Re: 7000 Wisconsin Avenue

RE: Preliminary Plan No. 12020090
7000 Wisconsin Avenue

Impossible Mission - 7000 Wisconsin

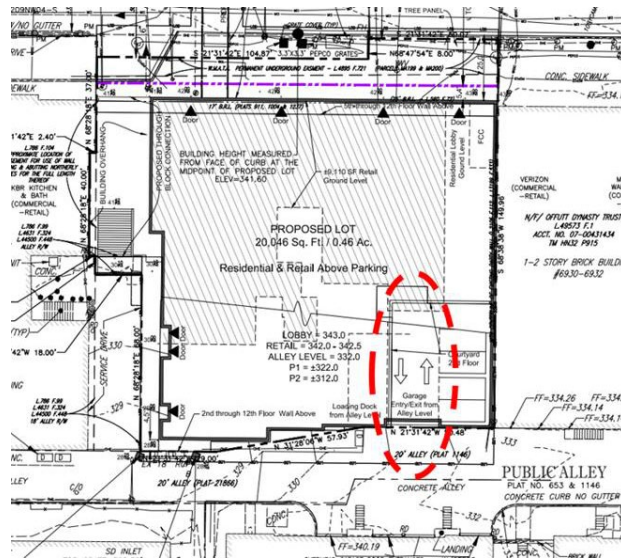
1. Are you saying 15.9 will go to 25 ft ?

2. How far back from the exit on woodmont will 7000s vehicles enter the alley into a already traffic stream awaiting in a long line?

As a result of the redevelopment of 7000 Wisconsin Avenue, the minimum clear alley width will be increased along the site frontage to a minimum width of 25'. This clear width will increase to a maximum of 30 feet along the site frontage.

The proposed garage entrance to the 7000 Wisconsin Avenue project is located toward the southern corner of the Site, as highlighted with the red circle, below. If you would like to see a full size version of this image, please visit:

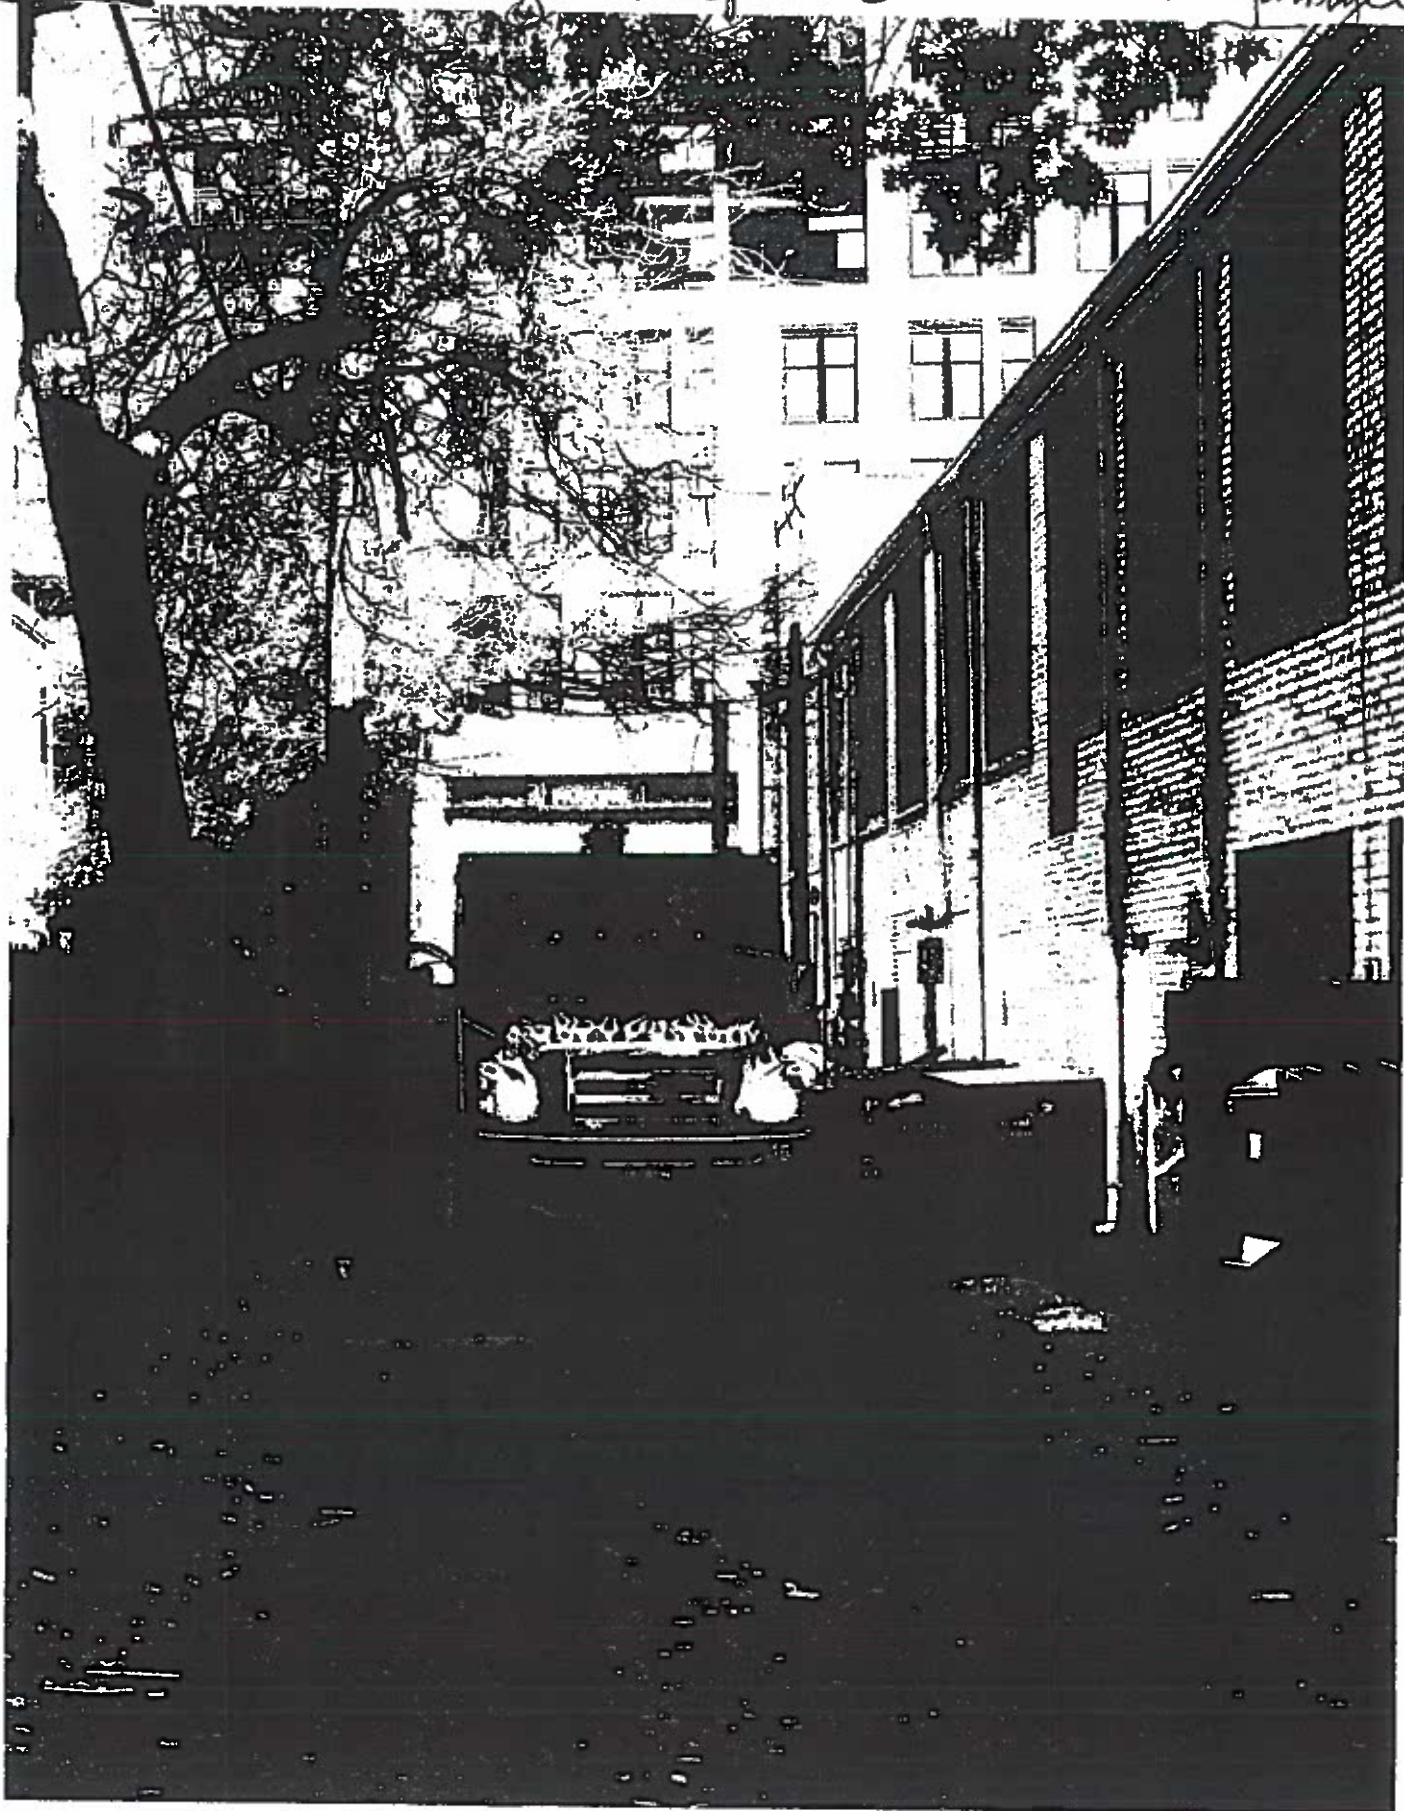
- 1 An alley already on overload.
- 2 Structure, Constructed, narrow 16 ft ^{(15.9} sections, Telephone poles, cement barriers multiple houses with garages.
- 3 Walkway - alley's residents frequently use our alley to reach destinations, deposit garage, daily recreation and exercise.
- 4 Transportation - ^{Add a} 17 story building, several hundred people, 200+ apartments 135 parking spaces = 135 cars and Trucks dumped solely on a narrow malstructured, ill maintained, with potholes and often awkward for even Two cars to pass, Transport Trucks 26+ feet ^(long) coming and going, 8 foot wide garbage trucks 2x weekly; how? delivery and repair trucks and a party in a pear tree.
- Result is stagnation, long, long piled up lines of cars.
- 5 Traffic - Commuters will be stymied to form long, long lines of frustrated people trying to enter Woodmont Ave will take an hour or more. The 3 lanes are

backed up for past our alley exit—
Only one car may seek entry at a time!
The 60+ cars trying to enter the alley—how?
Traffic will become impossible
Then there's Wisconsin Ave, almost
always backed up in a tight, modus
operandi for 2+ blocks in all
directions. how?
